Serviceordre – Materiell

SERVICEORDRE – 2013-4

SERVICE BULLETIN SPSB009

SUBJECT: SUPPLIER/VENDOR RECALL OF PS70104 HOUSINGS (METAL FLEX HOISING INC)

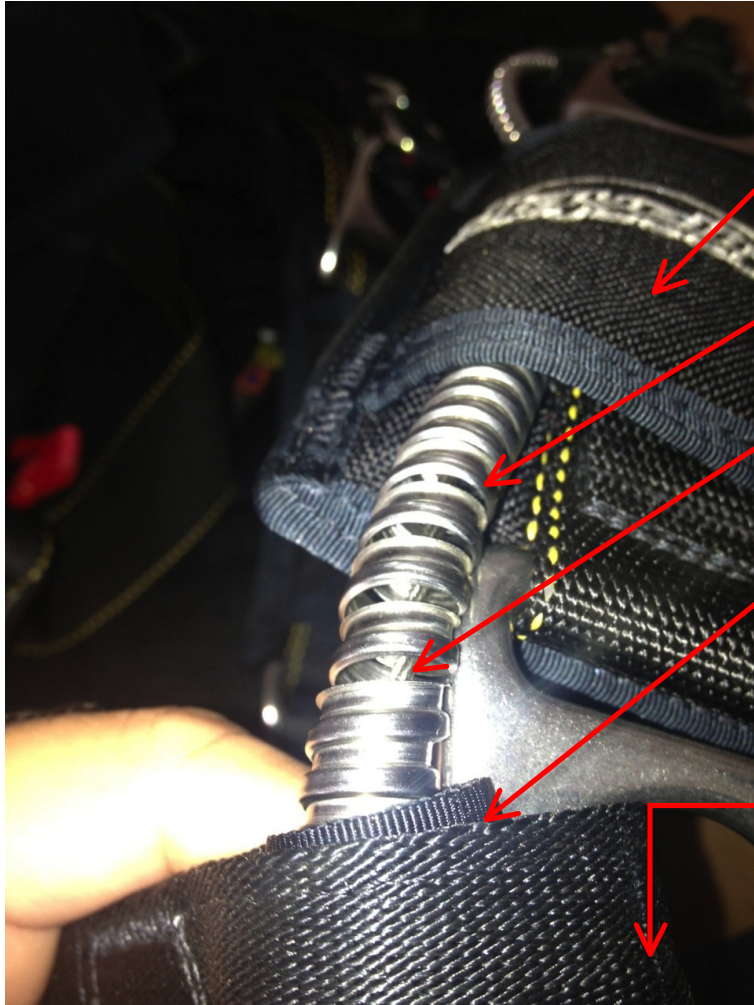
Who can inspect: Anyone can inspect this area. See photos below.

WEARERS LEFT SIDE:

RESERVE RIPCORD HOUSING (LOWER END)

SEPERATED HOUSING (FOR REFERENCE)

What to inspect: All JA101-XX harness container systems listed in table above. Inspect Reserve Ripcord housing.

If the serial number is listed in the above table, inspect the available exposed reserve ripcord housing. Locate the lower end of the housing, which is clamped to the Main Lift Web, just above the reserve ripcord pocket. Inspect the exposed length of housing from the clamp upwards; ensure that the coil has not separated/unraveled. Be sure to inspect the section that is routed through the chest strap.

A. HOUSING FOUND TO BE INTACT (GOOD): The rig may continue to be jumped with periodic monitoring until the next repack cycle or earlier elective replacement. However this housing must be replaced at the next repack cycle. See <http://www.sunpath.com/support/HousingReplacement.pdf> for instructions for your rigger to complete the replacement of the housing.

B. HOUSING FOUND TO BE SEPERATED/UNRAVELLED (BAD): The housing must be replaced before the next jump by a certificated senior or master parachute rigger (or foreign equal) or the manufacturer. See <http://www.sunpath.com/support/HousingReplacement.pdf> for instructions for your rigger to complete the replacement of the housing or instructions to send your system back to the manufacturer.

Replacement of Javelin Odyssey reserve ripcord housing

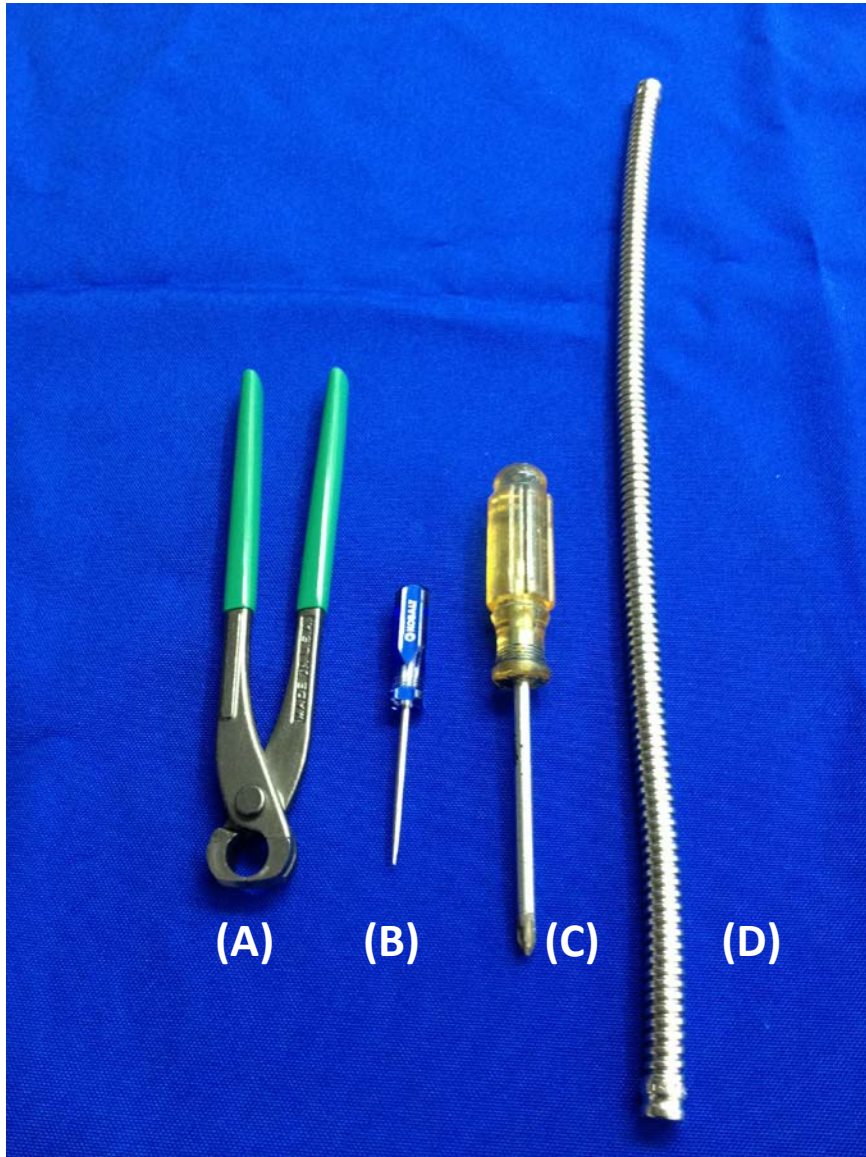
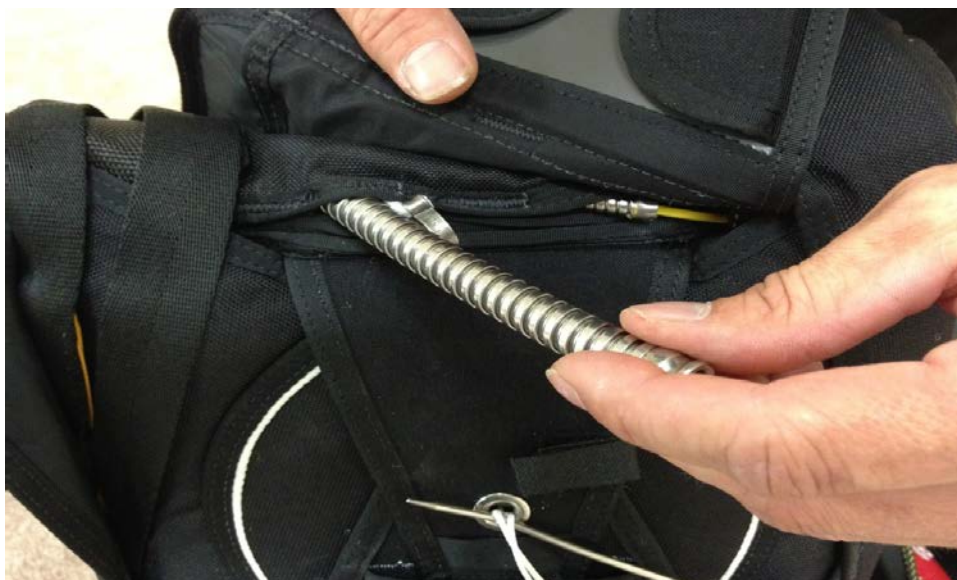
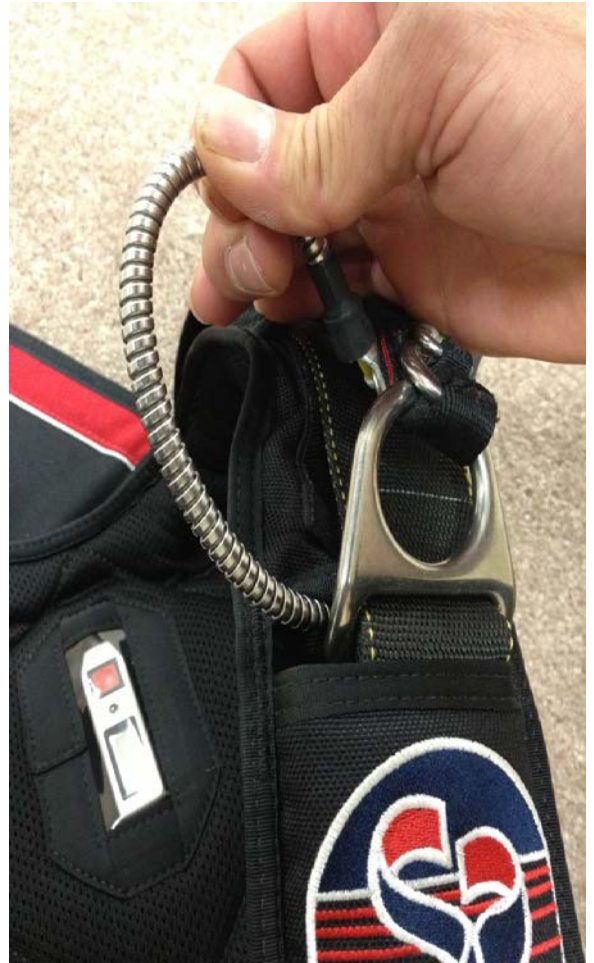
- 1) Remove reserve ripcord and cover exposed hook velcro on the handle.

2) Insert the pick into the pinch of the Oetiker Clamp, be careful not to damage the Spectra line . Insert screwdriver into reserve housing see pic (B).

3) Hold the screwdriver in the reserve housing firmly , and gently start to open the Oetiker clamp by prying the pick back and forth until the reserve housing is loose. See page (6)

5) Push reserve ripcord housing up inside the ring cover, to expose the opposite end.

8) Remove Oetiker Clamp from reserve ripcord housing

9) Gently remove reserve ripcord housing from system and DISCARD

10) Pull left side cutaway housing from ring cover as shown

- 11) Start by sliding the reserve ripcord housing under the ring cover. **Important:** Route the housing under the cutaway housing during installation.

12) Install end of housing into Oetiker Clamp, then re-clamp with Oetiker Clamping tool as shown

13) Pull the slack out of reserve ripcord housing as shown

14) Insert reserve housing through the buffer on chest strap, then insert housing into Oetiker clamp

15) Re-clamp with Oetiker clamping tool as shown.
